**NEW YORK STATE THRUWAY AUTHORITY
DEPARTMENT OF ENGINEERING**

**ALBANY, NY
FEBRUARY 8, 2024**

**AMENDMENT NO. 1
TO**

**CONTRACT TANY 24-8
D214964
2" MILL AND INLAY, SAFETY
IMPROVEMENTS AND MISCELLANEOUS WORK
BETWEEN MILEPOST 47.6+/- AND MILEPOST 60.1+/-
IN THE NEW YORK DIVISION
OF THE NEW YORK STATE THRUWAY
IN ORANGE COUNTY**

TITLE OF PROJECT: PAVEMENT RESURFACING AND SAFETY IMPROVEMENT
 CONTRACT NUMBER: TANY 24-8
 LOCATION OF PROJECT: NY DIVISION MP 48.0 TO 60.1
 DATE: 1/2024
 TITLE OF DRAWING: MISCELLANEOUS DETAILS
 DRAWING NUMBER: MD-1

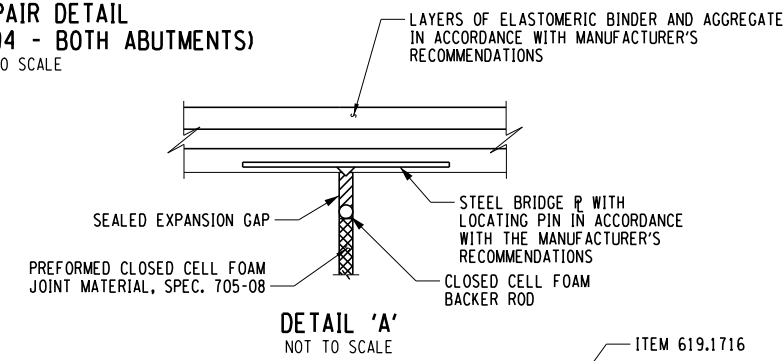
7. **DELETE** Drawing Number MD-1, Sheet 60 of 108, and **SUBSTITUTE** with the attached Drawing Number MD-1, Sheet 60-A1 of 108. Reference to Item 580.51030525 was added to the Joint Repair Detail (Both Abutments of bridges at MP 49.78 and MP 55.94). Added items description box.

TITLE OF PROJECT PAVEMENT RESURFACING AND SAFETY IMPROVEMENT	CONTRACT NUMBER: TANY 24-8
LOCATION OF PROJECT NY DIVISION MP 48.0 TO 60.1	DATE: 1/2024
TITLE OF DRAWING MISCELLANEOUS DETAILS	DRAWING NUMBER: MD-2

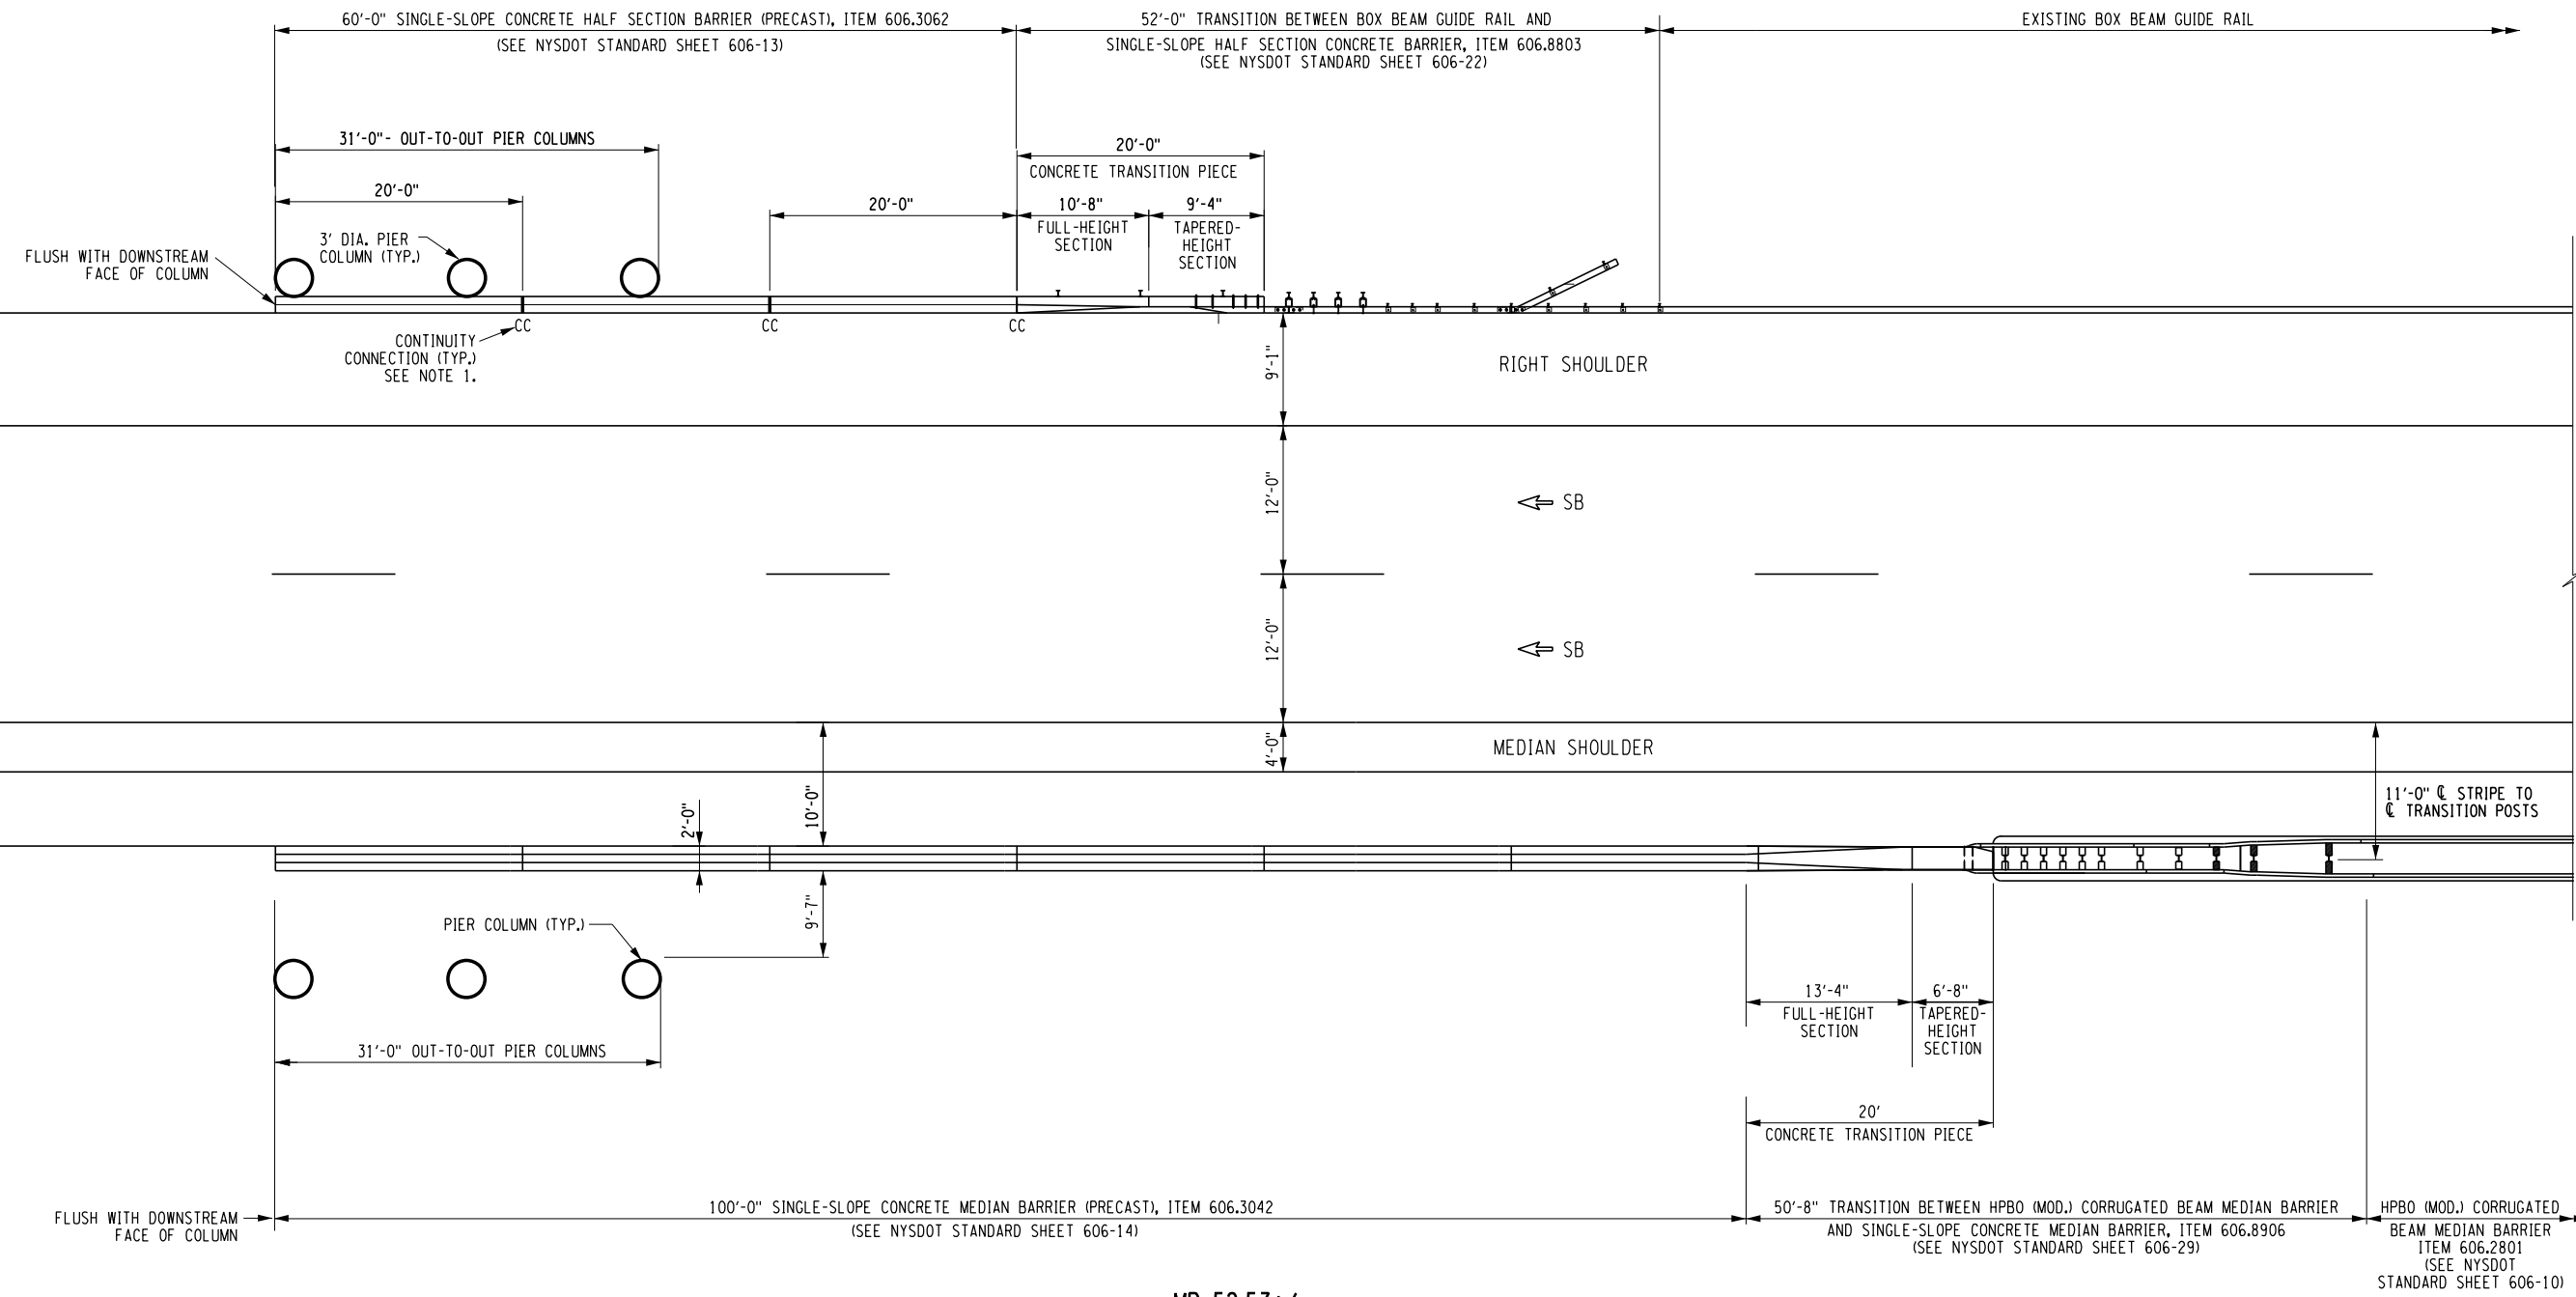
8. **DELETE** Drawing Number MD-2, Sheet 61 of 108, and **SUBSTITUTE** with the attached Drawing Number MD-2, Sheet 61-A1 of 108. The proposed locations of concrete barrier joints have been updated.

TITLE OF PROJECT PAVEMENT RESURFACING AND SAFETY IMPROVEMENT	CONTRACT NUMBER: TANY 24-8
LOCATION OF PROJECT NY DIVISION MP 48.0 TO 60.1	DATE: 1/2024
TITLE OF DRAWING MISCELLANEOUS DETAILS	DRAWING NUMBER: MD-3

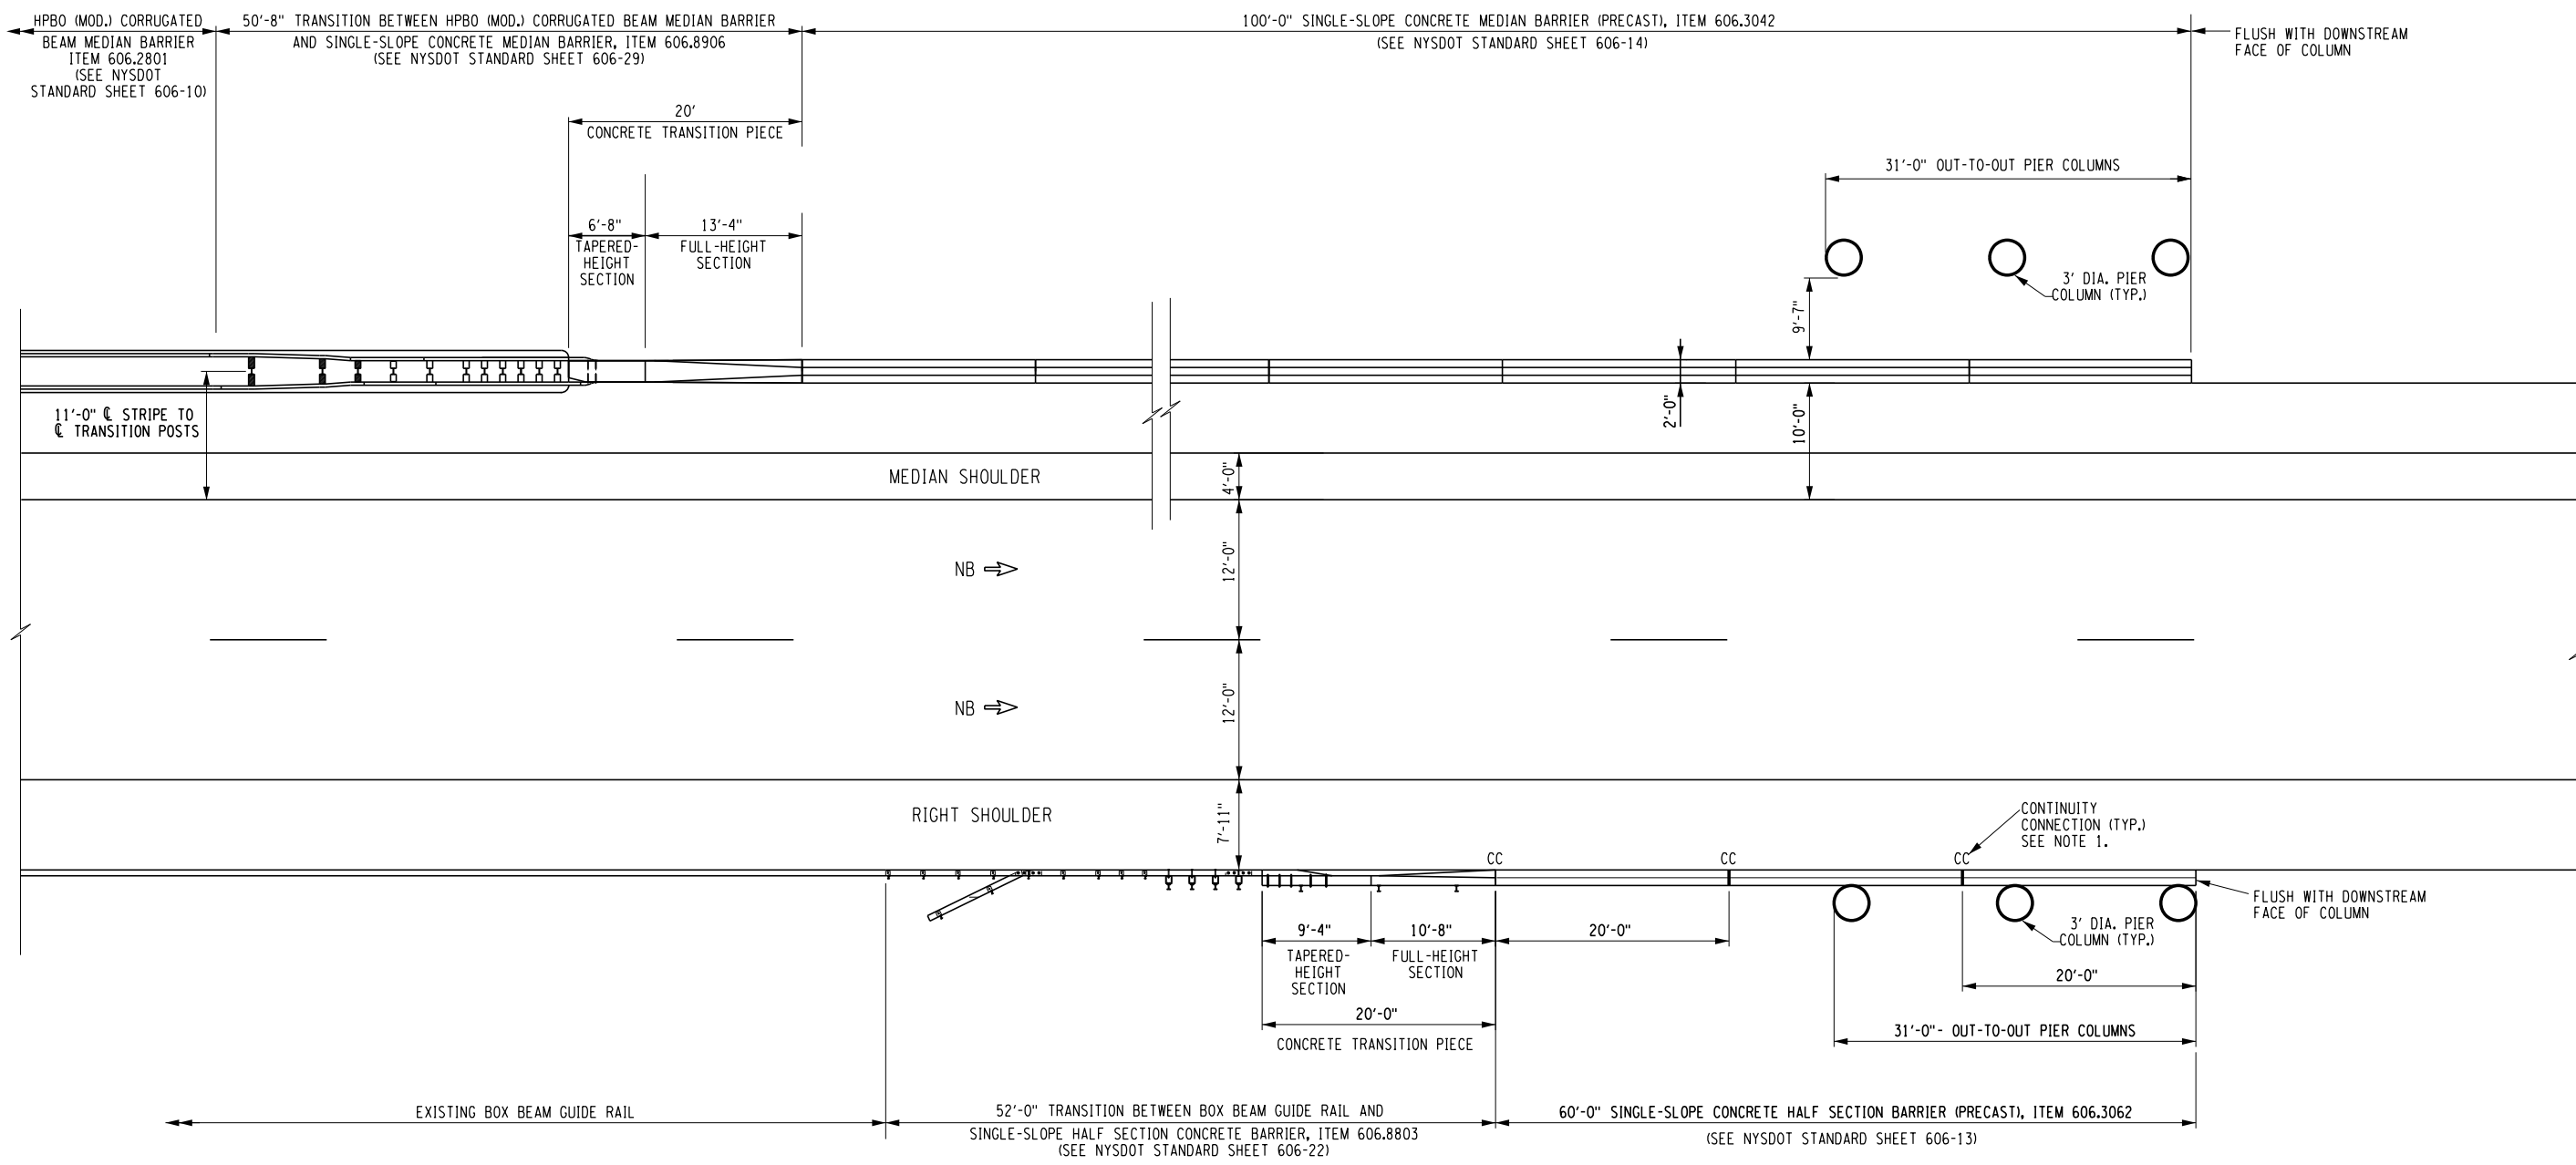
9. **DELETE** Drawing Number MD-3, Sheet 62 of 108, and **SUBSTITUTE** with the attached Drawing Number MD-3, Sheet 62-A1 of 108. The proposed locations of concrete barrier joints have been updated.

Thruway Authority	TITLE OF PROJECT PAVEMENT RESURFACING AND SAFETY IMPROVEMENT	CONTRACT NUMBER: TANY 24-8
	LOCATION OF PROJECT NY DIVISION MP 48.0 TO 60.1	DATE: 1/2024
TITLE OF DRAWING MISCELLANEOUS DETAILS	DRAWING NUMBER: MD-4

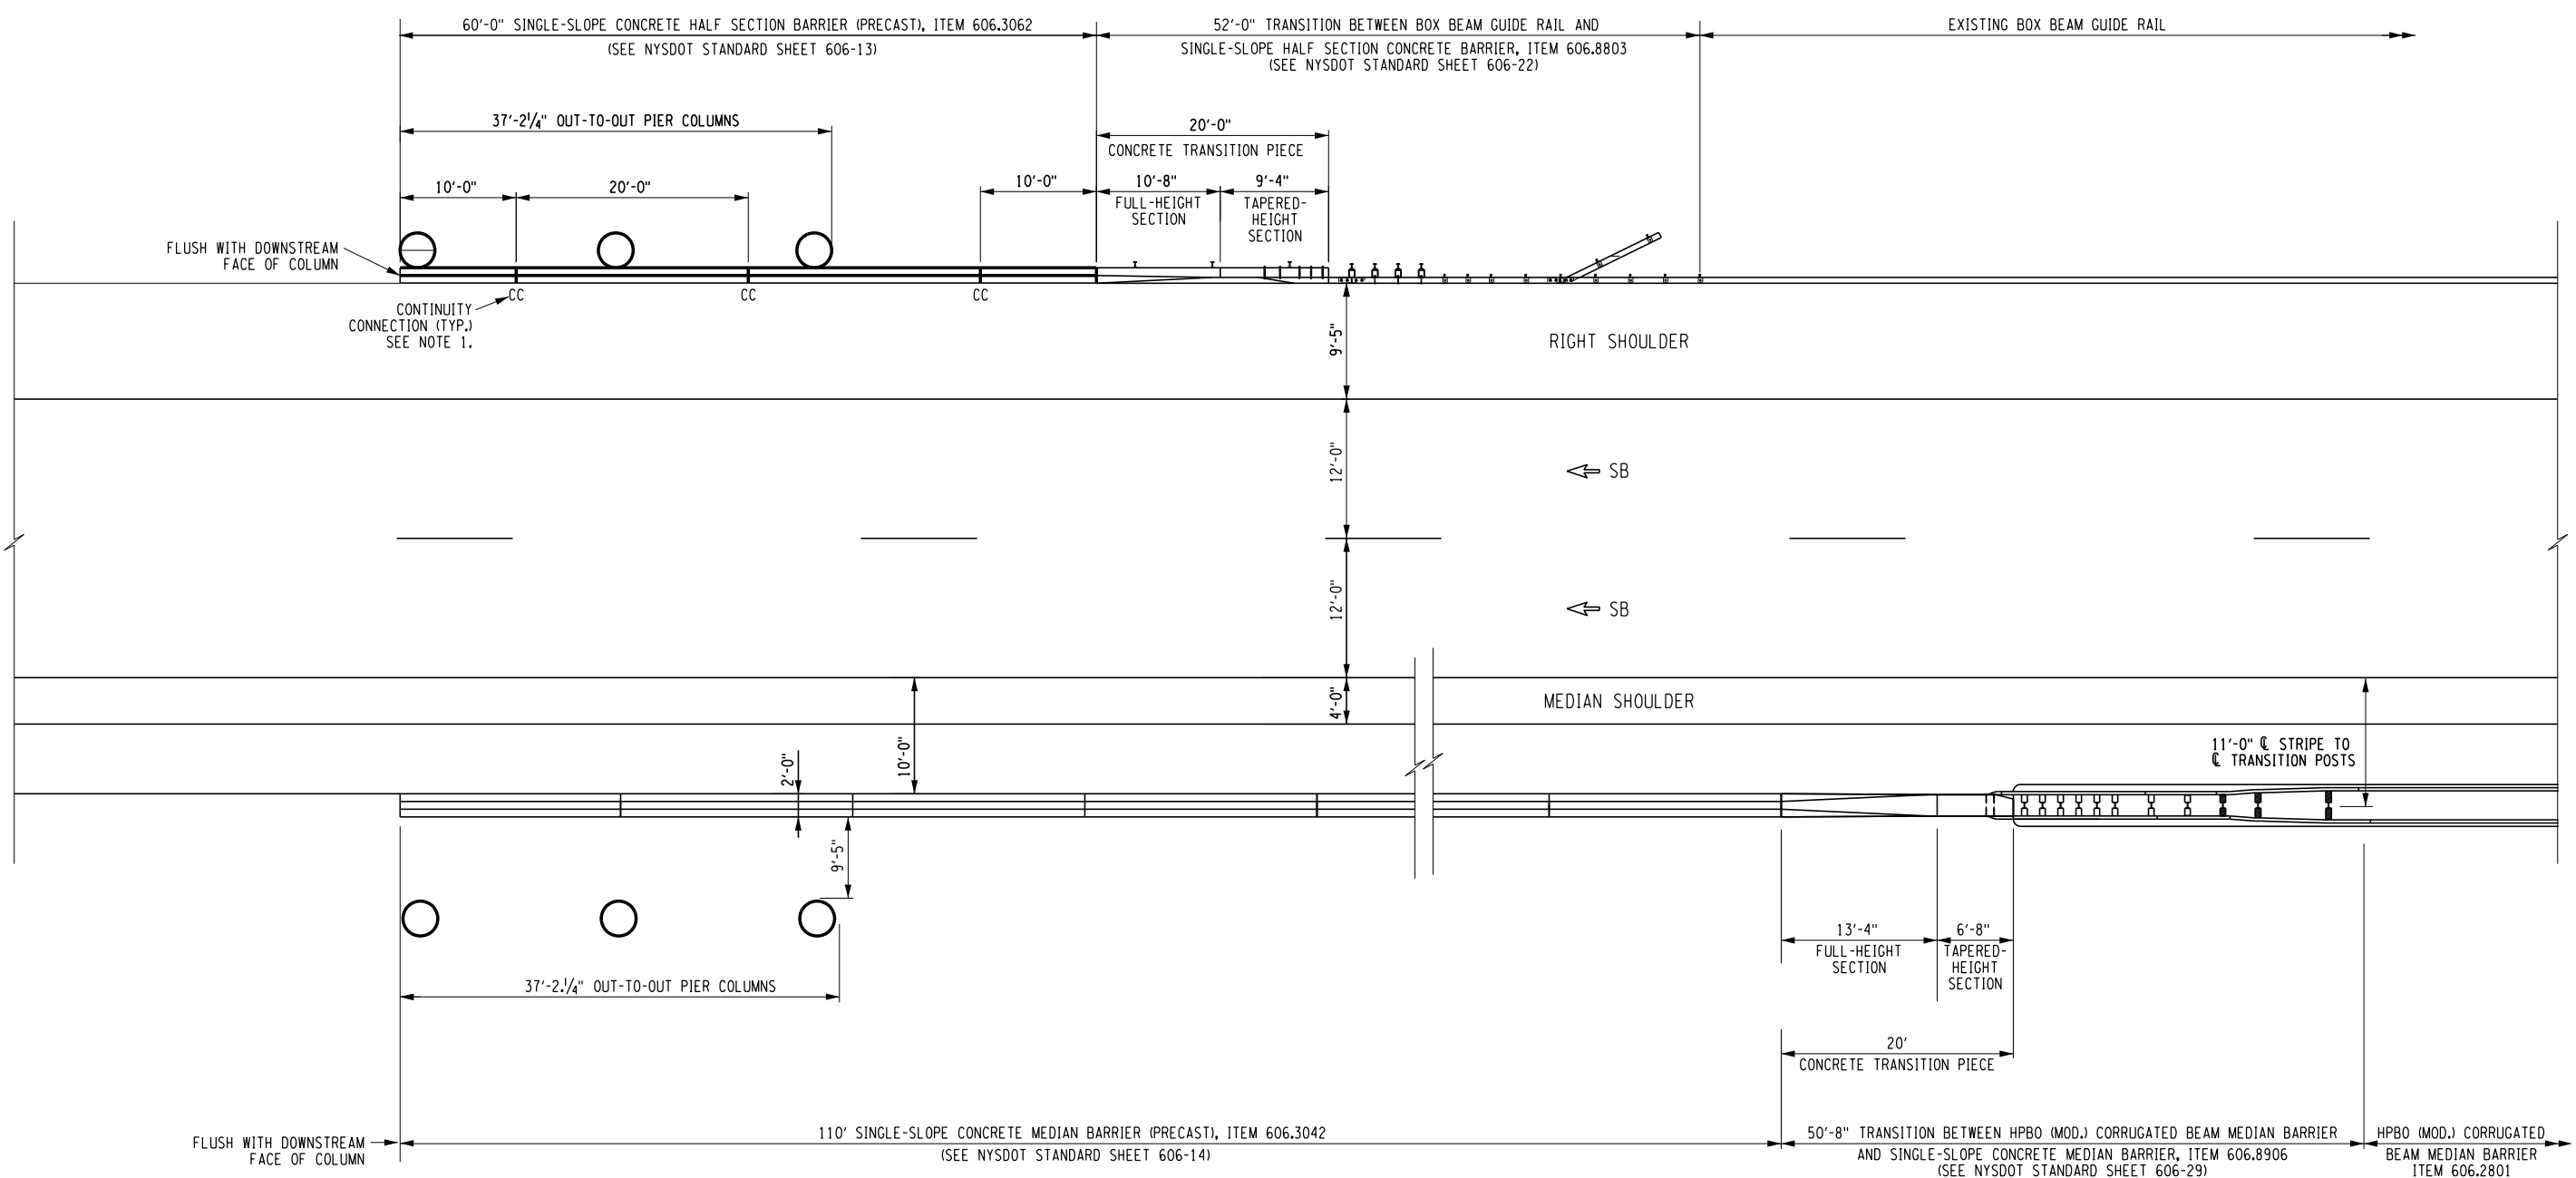
10. **DELETE** Drawing Number MD-4, Sheet 63 of 108, and **SUBSTITUTE** with the attached Drawing Number MD-4, Sheet 63-A1 of 108. The proposed locations of concrete barrier joints have been updated. Changed right side barrier length. Added Note 3.
